UNITED STATES PATENT AND TRADEMARK OFFICE

APPLICATION NO.	FILING DATE	FIRST NAMED INVENTOR	ATTORNEY DOCKET NO.	CONFIRMATION NO.
10/603,250	06/25/2003	John T. Ulman	PPC-5006	3681
27777	7590	06/24/2005	EXAMINER	
PHILIP S. JOHNSON JOHNSON & JOHNSON ONE JOHNSON & JOHNSON PLAZA NEW BRUNSWICK, NJ 08933-7003			BOGART, MICHAEL G	
			ART UNIT	PAPER NUMBER
			3761	
DATE MAILED: 06/24/2005

Office Action Summary

DETAILED ACTION

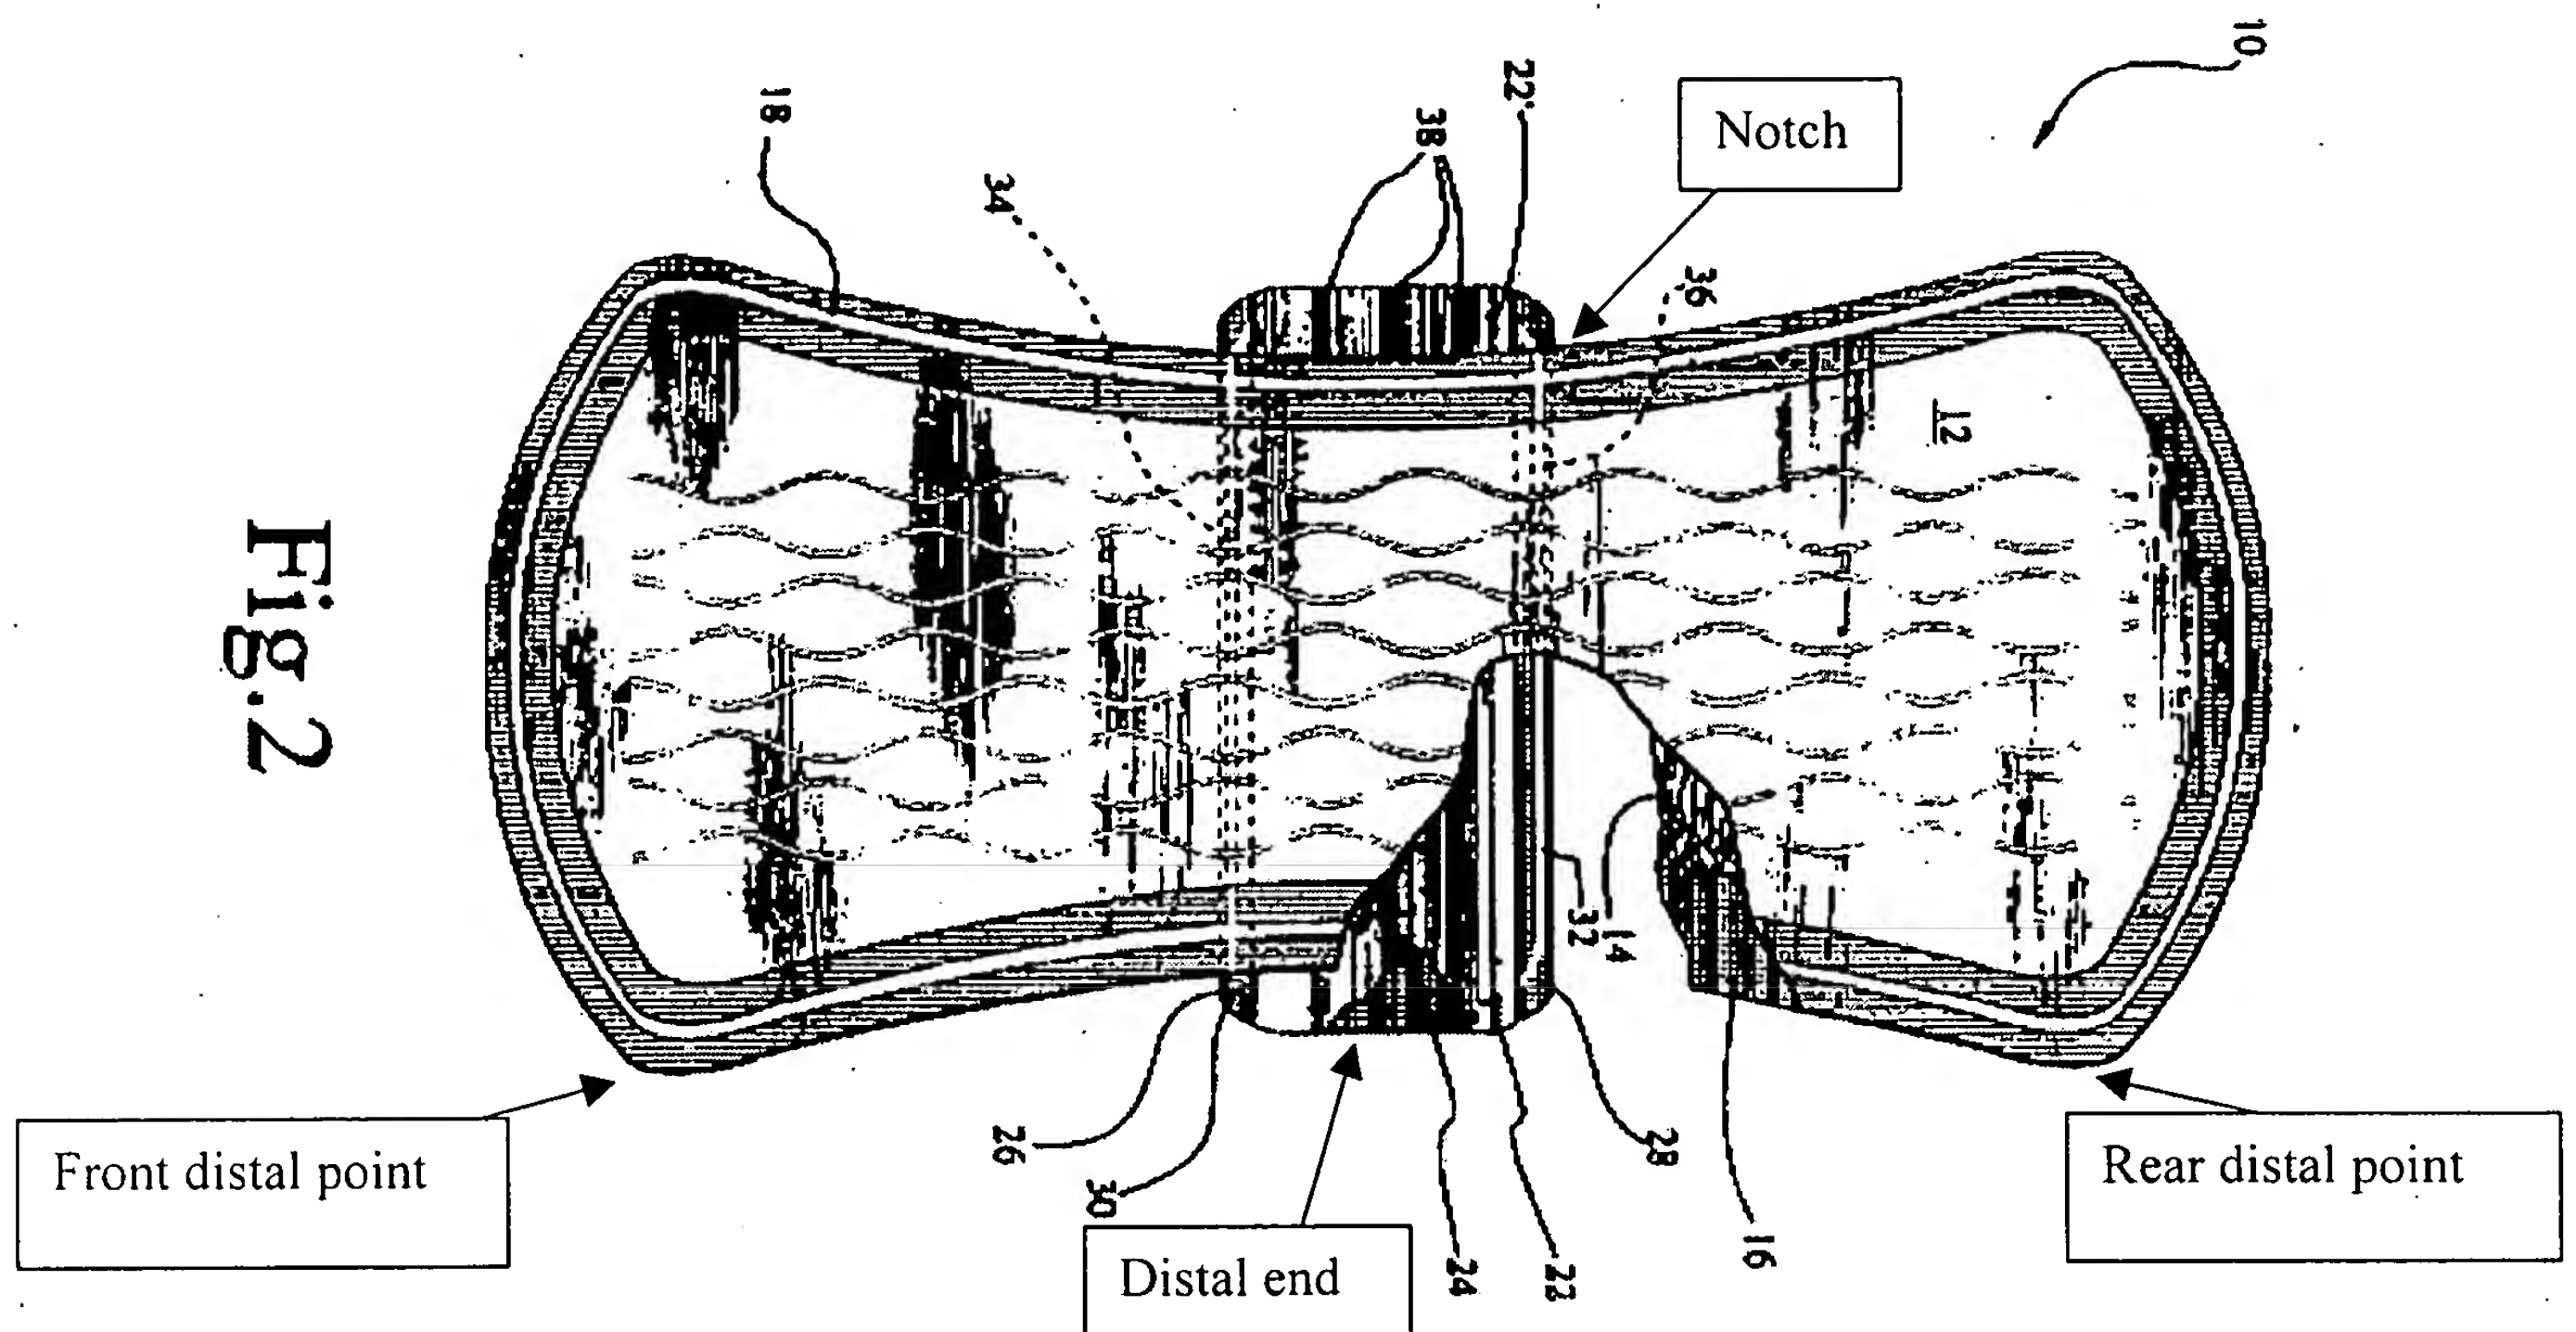
Regarding claim 1, Brisebois teaches a sanitary napkin (10) comprising:

a main body (12, 14, 16), the main body (12, 14, 16) comprising a fluid-permeable cover layer (12), a liquid-impervious barrier layer (16) and an absorbent system (14) intermediate the

cover layer (12) and the barrier layer (16), wherein the main body (12, 14, 16) comprises a front portion, a rear portion and a center portion intermediate the front portion and the rear portion, and wherein the front portion extends laterally to at least one outermost front distal point and the rear portion extends laterally outward to at least one outermost rear distal point; and

a side flap (22) projecting laterally outward from the absorbent system (14), extending laterally outward from a proximal edge (18) of the center portion and adapted to be folded over a crotch portion of a user's undergarment in use, the side flap (22) extending laterally outward from the proximal edge (18) to a distal end, wherein the distal end is not substantially laterally outward from the at least one outermost front distal point and the distal end is not substantially laterally outward from the at least one outermost rear distal point, and wherein the at least one outermost front distal point, the at least one outermost rear distal point, and the side flap (22) are each positioned on a single side of a longitudinally extending center line of the sanitary napkin (10)(col. 5, line 63-col. 6, line 33)(see figure 2, below).

Regarding claim 5, Brisebois teaches that the anterior notch boundary includes portions that are laterally inward from the outermost front distal point (figure 2).

wherein the outermost distal point of the flap (22) is not laterally outward from the at least one outermost front distal point and the outermost distal point of the flap (22) is not laterally outward from the at least one outermost rear distal point, and wherein the at least one outermost front distal point, the at least one outermost rear distal point, and the side flap are each positioned on a single side of a longitudinally extending centerline of the sanitary napkin, and wherein the flap (22) is, at least in part, structurally isolated from the front part by an anterior notch, and the flap (22) is, at least in part, structurally isolated from the rear portion by a posterior notch (figure 2).

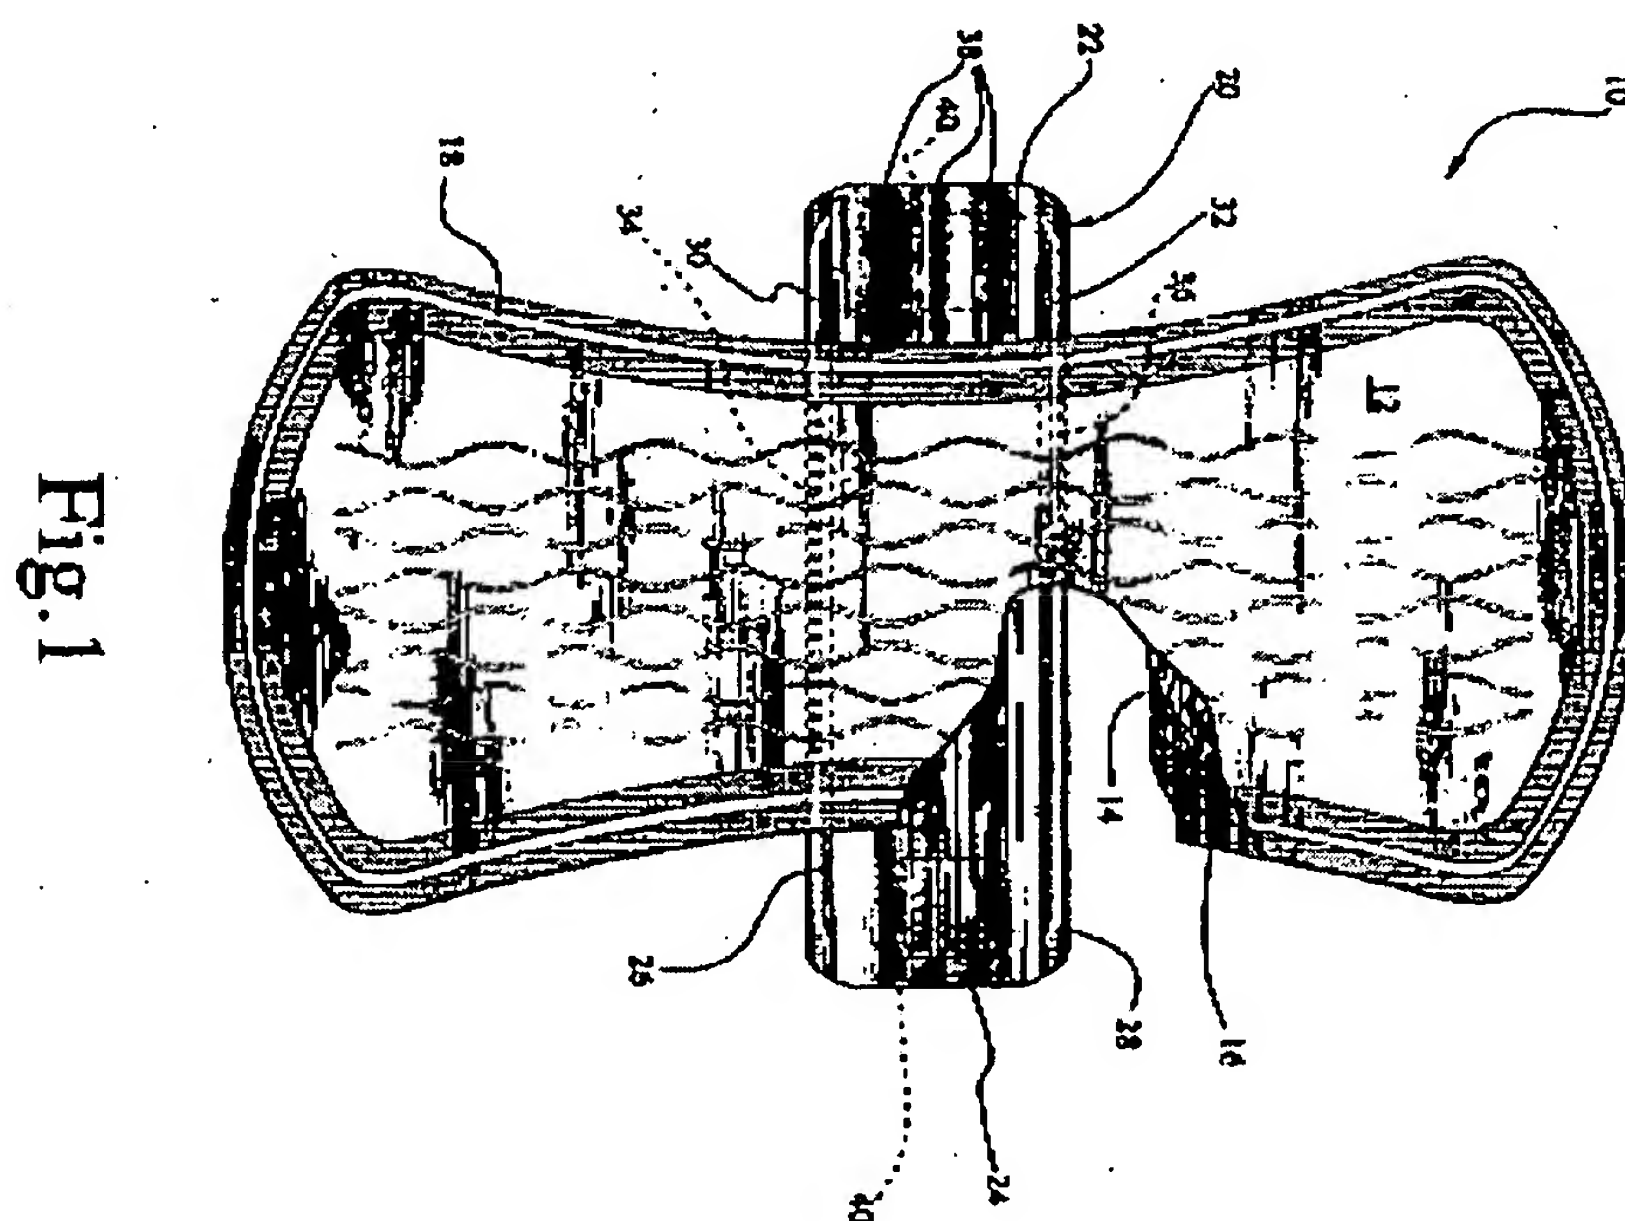
Regarding claim 7, Brisebois teaches a flap positioning adhesive (40) is on the bottom surface of the liquid impervious barrier layer (16)(figure 1, below).

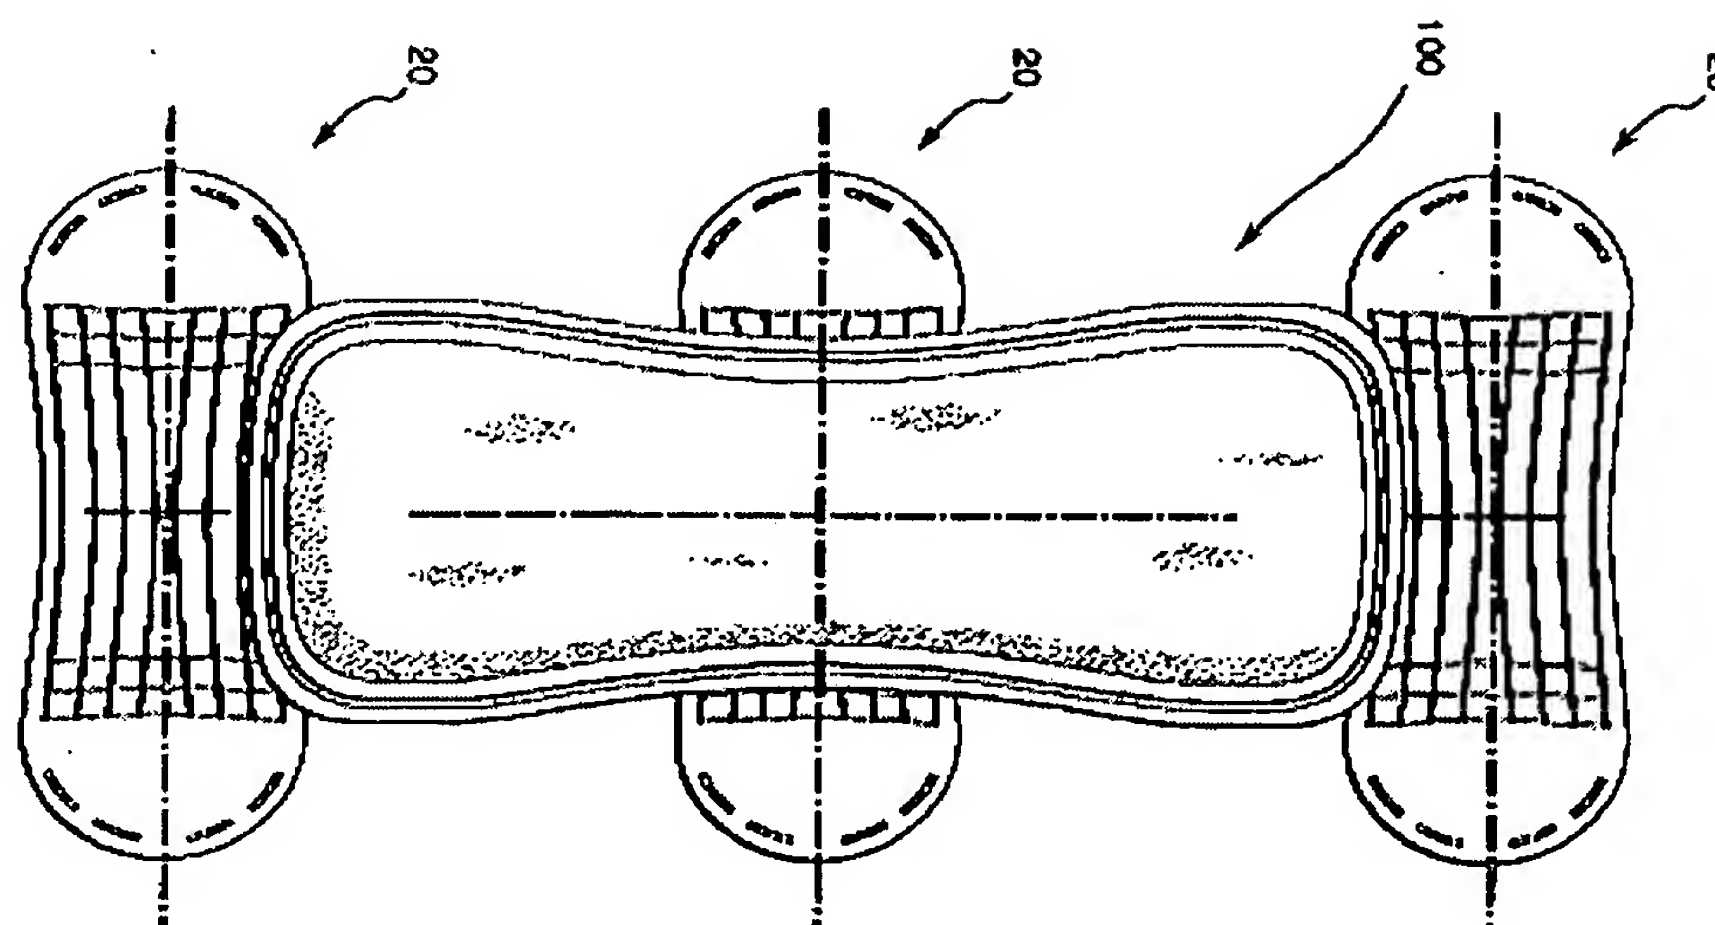
Regarding claim 1, '311 teaches a sanitary napkin (20) comprising:

a main body (22), the main body (22) comprising a fluid-permeable cover layer, a liquid-impervious barrier layer (41) and an absorbent system (40) intermediate the cover layer and the barrier layer (41), wherein the main body (22) comprises a front portion, a rear portion and a center portion intermediate the front portion and the rear portion, and wherein the front portion extends laterally to at least one outermost front distal point and the rear portion extends laterally outward to at least one outermost rear distal point; and

a side flap (20) projecting laterally outward from the absorbent system (40), extending laterally outward from a proximal edge (24, 26) of the center portion and adapted to be folded over a crotch portion of a user's undergarment in use, the side flap (20) extending laterally outward from the proximal edge (24, 26) to a distal end, wherein the distal end is not substantially laterally outward from the at least one outermost front distal point and the distal end is not substantially laterally outward from the at least one outermost rear distal point, and wherein the at least one outermost front distal point, the at least one outermost rear distal point, and the side flap (20) are each positioned on a single side of a longitudinally extending center line of the sanitary napkin (20)(see figure 6, below).
